EV Charging Infrastructure Risk Assessment

BP Sonning Cutting
709 London Road
Woodley, Reading
Berkshire
RG6 1BG

1.4	Document title	BP Sonning Cutting EV Charging Infrastructure Risk Assessment
1.5	Revision status	1.0
1.6	Date of initial report	14th August 2025
1.7	Date this version of the report issued for client review

18. "GUIDANCE FOR DESIGN, CONSTRUCTION, MODIFICATION, MAINTENANCE AND DECOMMISSIONING OF FILLING STATIONS" (BLUE BOOK 5TH EDITION) HAZARDOUS ZONES

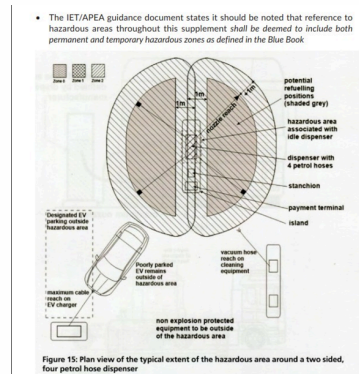
17. STORAGE OF FLAMMABLE AND COMBUSTIBLE MATERIALS OVERVIEW		
Ref	Name	Description
17.1	Storage of flammable and combustible materials overview -overview	It is considered best practise to ensure that flammable and combustible materials that may aid the rapid spread of fire are not stored within the EV charging area. Combustible materials may also include landscaped areas which can create a fire pathway from the EV charging area. It is important to note that liquids and pressurized gasses though not flammable may react adversely to extreme heat radiation. Despite the fact that the pumps are marked as having extra-long hoses they all the same standard length (4.3m) and the sign is aimed at encouraging drivers to utilize the full length of the hose and prevent queues, as the hoses are already designed to be flexible enough for this purpose. The BP Global Appraise Document states that no works are required to the vents however protecting the vents from the jetting flame's from a battery pack or severe heat radiation should be considered.

Ref	Name	Description
19.1	Mitigation Storage of flammable and combustible materials	No combustible or flammable materials will be stored within the immediate vicinity of the proposed EV charging area. The proposed EV charging area sit over 40.0 metres from the main shop building In relation to what would be the closest EV charging bay. The vehicle refuelling area pumps run parallel to the proposed EV charging area. There is a distance of approximately 22.0 metres between the pumps and the closest EV charger. The distance between a charging EV and refuelling vehicle when both are parked correctly will be approximately 20.0 metres. If any maintenance works are required on the pumps a 10.0m separation distance should be maintained between the end of the closest proposed EV charging bay and the boundary of the safe working area established by any contractor working on the pumps. The proposed EV charging bays should be fitted with instructions for customers stating that they must park correctly within EV charging bays. The end of the closest proposed EV charging bay will sit approximately 10.0m from the closest below fuel tank chamber lid, a 10.0m separation distance should be maintained between the end of the closest proposed EV charging bay and the boundary of the safe working area established by any contractor working on the tanks when the chamber covers are removed. The tanker delivery area is located over 30.0 metres from the closest EV charging bay. The below ground fuel system vent pipes sit approximately 10.0 metres from the edge of the closest EV charging. the current scheme states that a fence may need to be created around the vent pipes so that there is no encroachment into the hazardous zone due to erroneous parking. It would be advisable to ensure that the fence is solid and treated with intumescent paint or made of block work to also protect the vents from heat radiation in the event of a vehicle fire in the proposed EV charging area. The car wash and jet wash separator vent pipe will remain active if the current drainage infrastructure for these facilities is retained. The location of the car wash and jet wash separator vents which are located along the Northern boundary line at the exit of the carwash should be checked with regards to their proximity to the new DNO substation to ensure there is no hazardous zone encroachment. The main forecourt oil and water separator and carwash / jet wash separators may sit within 10.0m of the closest proposed EV charging bays consideration should be given as to whether EV charging is permitted when the oil water separators are being emptied. It was noted that the boundary line behind the proposed EV charging area is comprised of a wooden panel fence that is covered in creeping Ivy. The vegetation should be removed from the wooden fence and it should be treated with intumescent wood stain or paint. In the event of a vehicle fire within the proposed EV charging area all fuel dispensing must cease Including fuel deliveries to site.
